AGENDA
CITY OF MAPLEWOOD
COMMUNITY DESIGN REVIEW BOARD
Tuesday, January 17, 2017
6:00 P.M.
Council Chambers - Maplewood City Hall
1830 County Road B East

Engineering Plan Review

Original submitted site plan

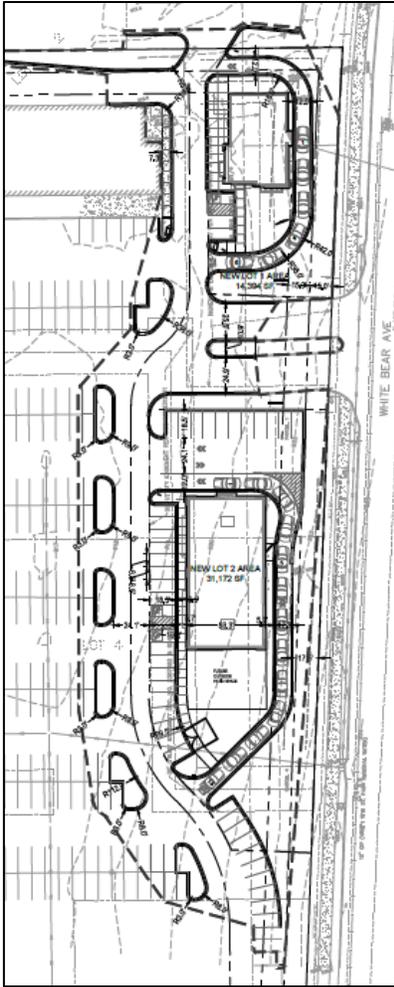
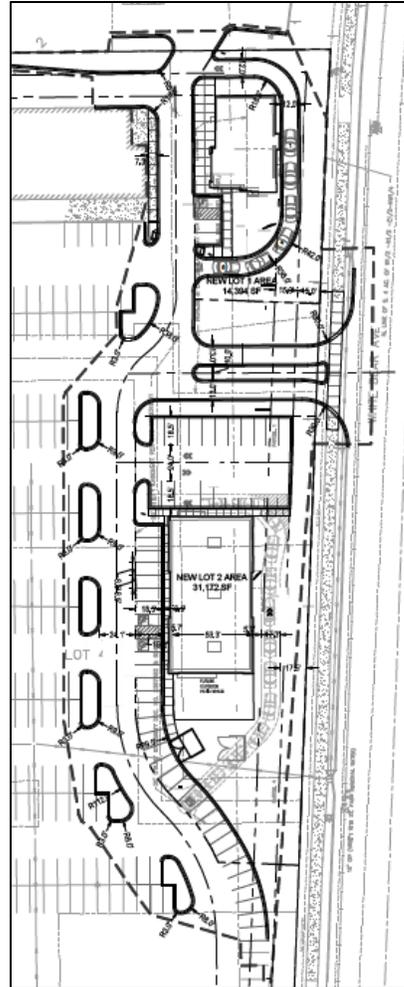
Given the CDRB's stated concerns regarding the overall site plan and parking waiver, the applicant revised its site plan to add 24 more parking spaces to the site plan. These additional 24 parking spaces, along with 72 proof-of-parking spaces, eliminates the need for a parking waiver. To add these spaces back into the site, the applicant eliminated a green space near the south building and reduced the width of the proposed drive through around the building.

As described in the applicant's letter, the site plan has been revised to:

"...address the concerns of the city. The most substantial change gives the north lot drive thru as much room as possible. The entry for the parking lot has been narrowed to an appropriate width to accommodate one-way traffic. This will slow cars down and relieve confusion by providing one lane for each direction of traffic. The entrance has also been shifted to the south to distance the north drive thru entrance from the parking entrance while aligning with the parking aisles."

The access off White Bear Avenue is proposed to be slimmed down which shifts the entry south of the existing entry. That additional space provides a larger buffer between the proposed building to the north and the entry access point. See the images on the next page to compare the original and revised site plans. A full sized sign plan has also been included in the agenda packet.
